**WHITEMARSH TOWNSHIP SHADE TREE COMMISSION
MEETING OF JULY 7, 2020 AT 7:00 PM**

UPDATE: The Knolls at Whitemarsh: 505 A Germantown Pike – See attached Arborist Memo.

901 Washington Street – SLD# 05-14 - Townhomes

901 WASHINGTON STREET – TREE REVIEW

TREE SURVEY PLAN

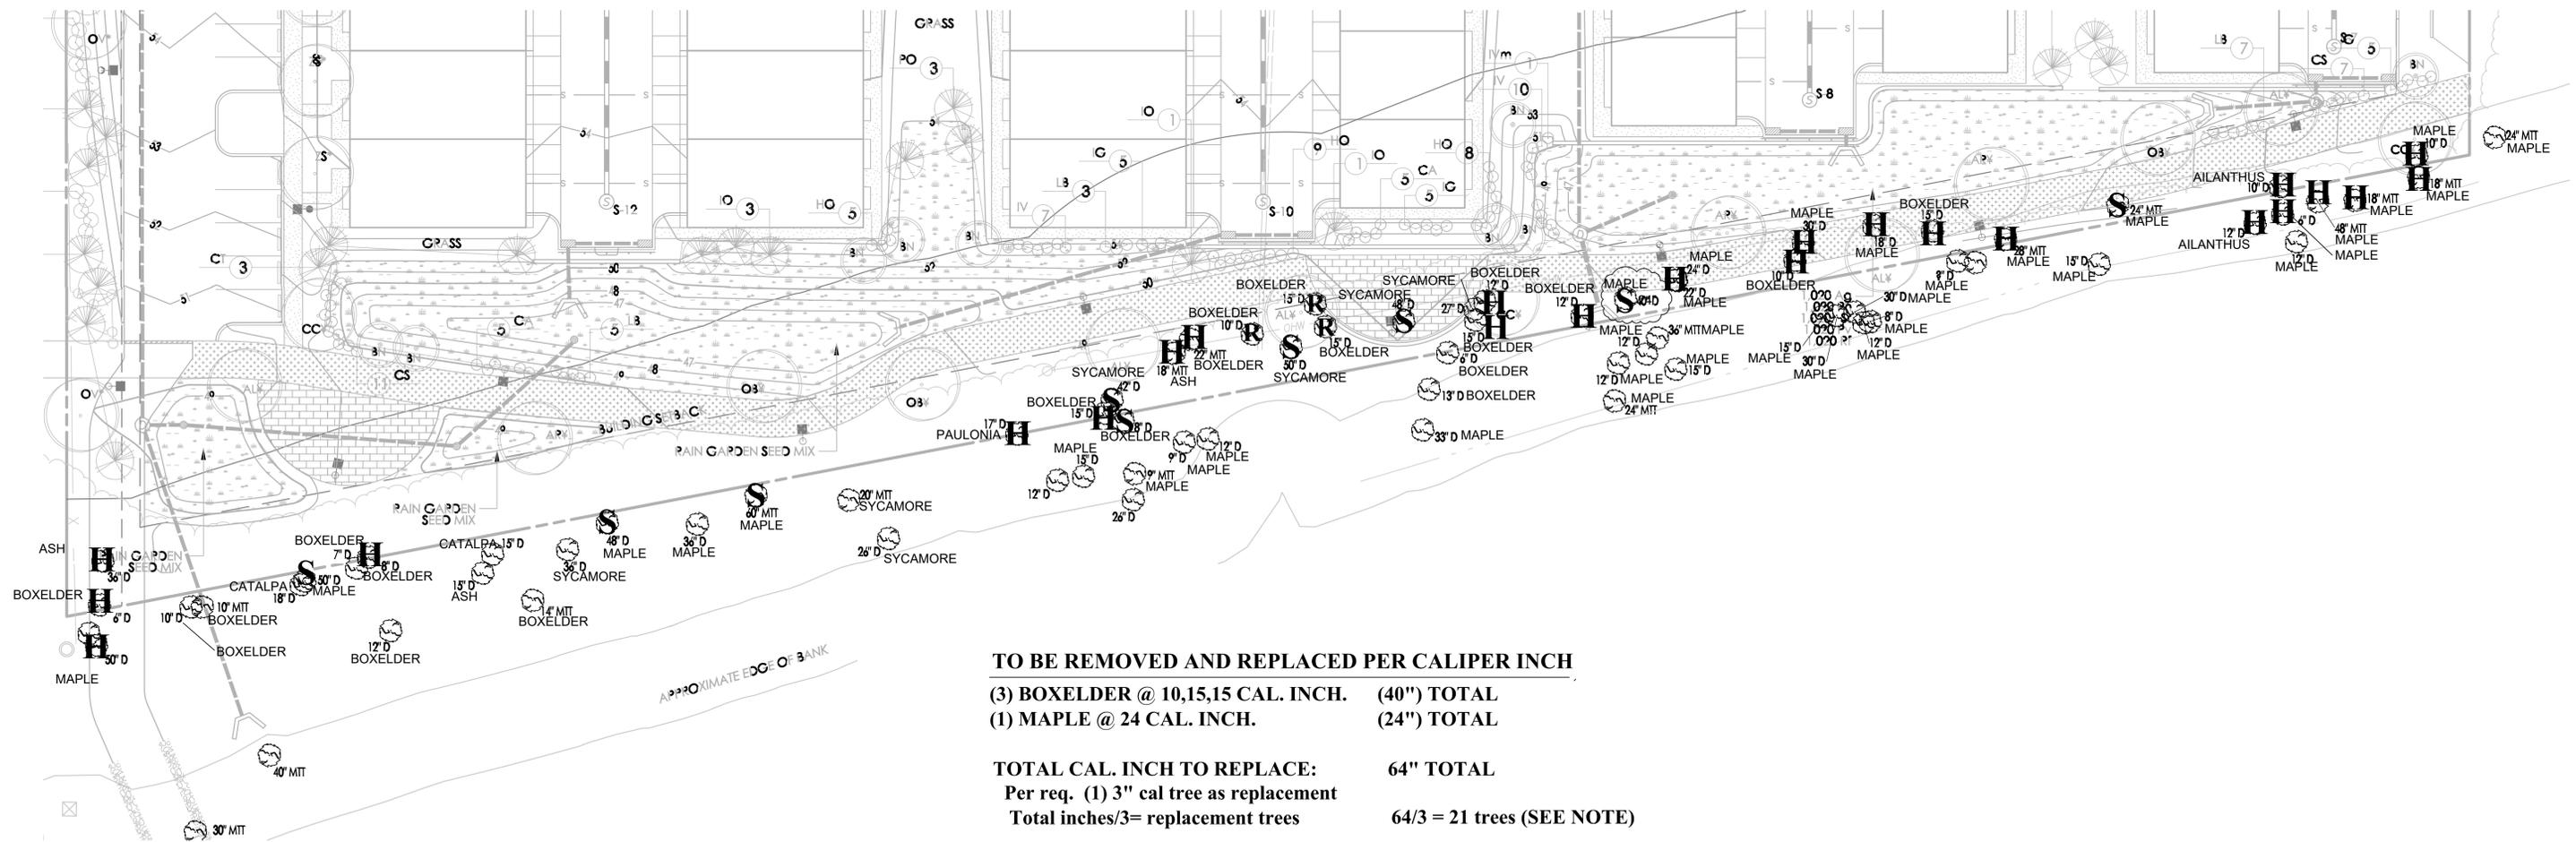
The applicant is removing a total of 18 hazard trees. These were confirmed during our walkthrough. In addition, they are removing 3 trees (no heritage) that will require 64 inches to be replaced or 21 3" trees. they are requesting a waiver to increase the percentage of shrubs from 20% to 43% for better stabilization of the riparian corridor, to decrease the percentage of trees from 50% to 27%, and to provide replacement trees at the rate of three (3) one inch caliper trees for each (1) three inch caliper tree required in order to improve the viability of trees planted on the riparian slope. (see revised Landscape plan).

In addition, they are removing more than 50% of the trees on their property along with a small percentage along the stream corridor.

I would like the applicant to further explain, in detail, the basis and benefits of utilizing the 1" stock and more shrubs so that the STC can review the objectives prior to the meeting so they have a full understanding of the concept.

In addition, I would like to see a deer protection detail for the smaller trees, a maintenance plan to manage the invasive plants and a more diverse palette of plants for the shade trees.
